Project	IEEE 802.16 Broadband Wireless Access Working Group < http://ieee802.org/16 >		
Title	New FEC structure suitable for CTC and mobile Cellular Operation of 802.16 OFDMA		
Date Submitted	2004-03-11		
Source(s)	Jaehee Cho, Soonyoung Yoon Panyuh Joo, Jaeweon Cho Samsung Electronics 416, Maetan-3dong, Paldal-gu Suwon-si, Gyeonggi-do Korea	Voice: Fax: jaehee1.cho@samsung.com soon,young,yoon@samsung.com panyuh@samsung.com jaeweon.cho@samsung.com	[+82-31-279-5 [+82-31-279-5

FEC structure suitable for CTC and mobile Cellular Operation of 802.16 OFDMA

Figure 1 – PRBS of the randomizer

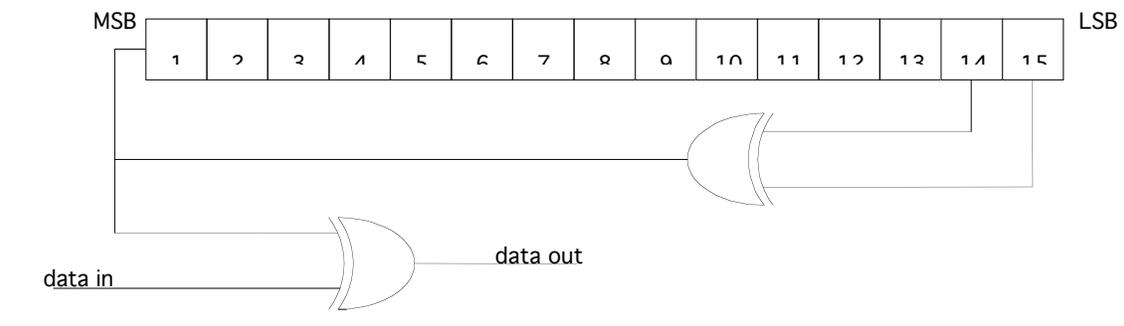
The Pseudo Random Binary Sequence (PRBS) generator shall be $1 + X^{14} + X^{15}$ as shown in Figure 1. Each data byte to be transmitted shall enter sequentially into the randomizer, MSB first. The seed value shall be used to calculate the randomization bits, which are combined in an XOR operation with the serialized bit stream of each burst. The randomizer sequence is applied to the output from the fragmentation block. The bit issued from the randomizer shall be applied to the encoder.

Figure 2 – Initialization construction for the PRBS of the randomizer

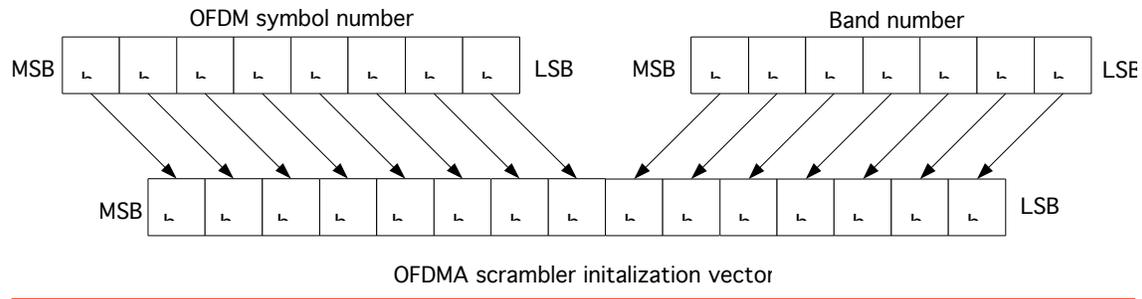
The scrambler is initialized with the vector created as shown in Figure 2. OFDMA symbol number is the number of the first OFDMA symbol where the burst is allocated. Band number is the number of the first band where the burst is allocated. OFDMA symbol number is counted after the preamble OFDMA symbols for DL and ranging OFDMA symbols for UL. The OFDMA symbol number and band number are counted from '0'.

Figure 3 – Encoder block diagram

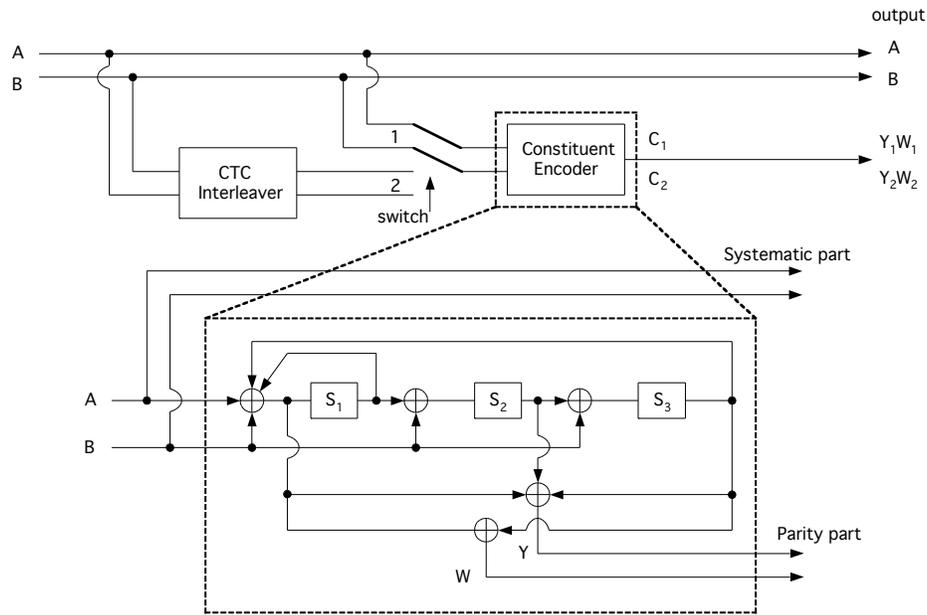
The Convolutional Turbo Code encoder, including its constituent encoder, is depicted in Figure 3. It uses a double binary CRSC (Circular Recursive Systematic Convolutional) code. The bits of the data to be encoded are alternatively fed to A and B, starting with the MSB of the first byte being fed to A, followed by the next bit being fed to B. The encoder is fed blocks of N_{EP} bits or N couples ($N_{EP}=2*N$ bits). The encoder packet size N_{EP} shall be limited to:

First, the encoder (after initialization by the circulation state S_{C_1} , see 0) is fed the sequence in the natural order (switch 1 in Figure 3) with incremental address $i = 1, 2, \dots, N$. This first encoding is called C_1 encoding.

Then the encoder (after initialization by the circulation state S_{C_2} , see 0) is fed by the interleaved sequence (switch 2 in Figure 3) with incremental address $i = 1, 2, \dots, N$. This second encoding is called C_2 encoding.

Figure 4 – Interleaving scheme (Subblock symbol separation, interleaving and grouping)

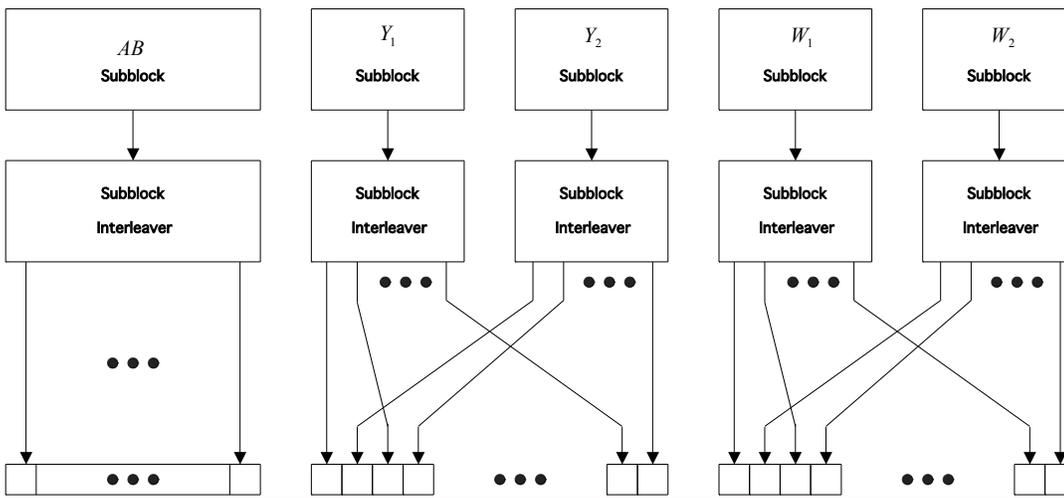
Interleaving consists of subblock symbol separation, interleaving, and grouping.

All of the encoded symbols shall be demultiplexed into 5 subblocks denoted AB , Y_1 , W_1 , Y_2 and W_2 . The encoder output symbols shall be sequentially distributed into 5 subblocks with the first and second encoder output symbols going to the AB subblock, the third to the Y_1 subblock, the fourth to the Y_2 subblock, the fifth to the W_1 subblock, the sixth to the W_2 subblock, etc. The AB subblock is the symbol-by-symbol multiplexed sequence of the input sequence A and B .

The channel interleaver output sequence shall consist of the interleaved AB subblock sequence followed by a symbol-by-symbol multiplexed sequence of the interleaved Y₁ and Y₂ subblock sequences followed by a symbol-by-symbol multiplexed sequence of the interleaved W₁ and W₂ subblock sequences. The symbol-by-symbol multiplexed sequence of interleaved Y₁ and Y₂ subblock sequences shall consist of the first output bit from the Y₁ subblock interleaver, the first output bit from the Y₂ subblock interleaver, the second output bit from the Y₁ subblock interleaver, the second output bit from the Y₂ subblock interleaver, etc. The symbol-by-symbol multiplexed sequence of

Figure 5 – PRBS of the coded symbol scrambler

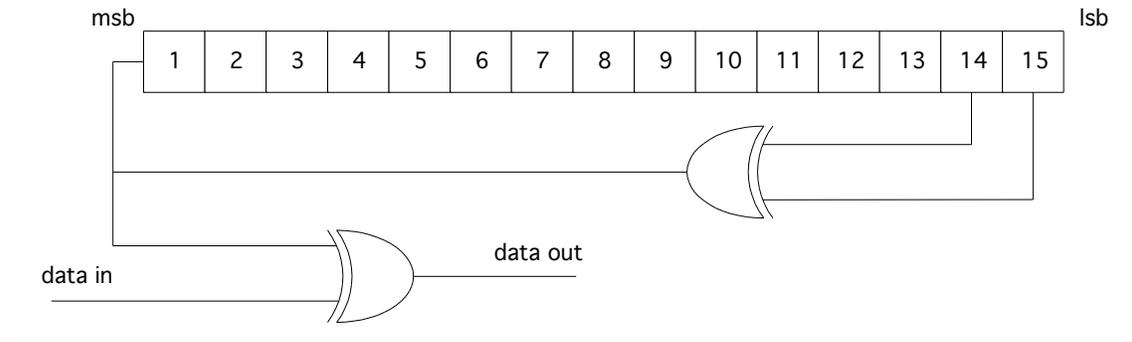
The coded symbol scrambler is performed on the FEC output bit stream, which means that each coded bit is scrambled by Pseudo Random Binary Sequence (PRBS). The PRBS generator shall be $1 + X^{14} + X^{15}$ as shown in Figure 5. Each coded bit to be modulated shall enter sequentially into the coded symbol scrambler, MSB first. The seed value shall be used to calculate the scrambled bits, which are combined in an XOR operation with the serialized bit stream of each FEC output stream. The bit issued from the scrambler shall be applied to the modulator.

Figure 6 –Initialization construction for the PRBS of the Coded Symbol Scrambler

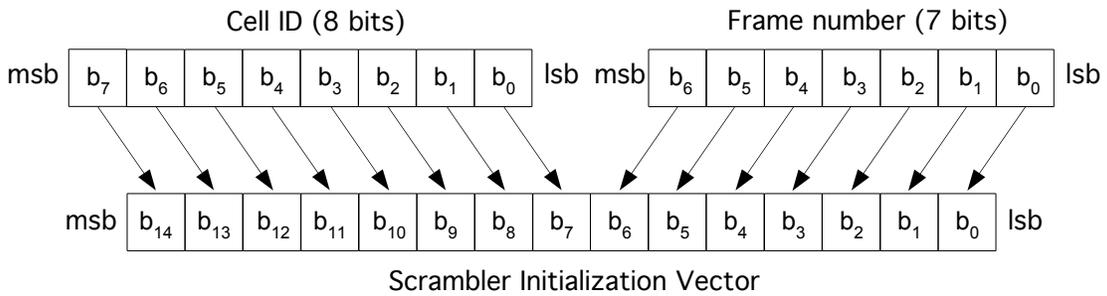
The scrambler is initialized with the vector created as shown in Figure 6. AP specific identifier (Cell ID) and frame number which is counted from the start of transmission of AP shall be the initialization vector. The Cell ID and frame number for the initialization vector are truncated by 8 bits and 7 bits, respectively.
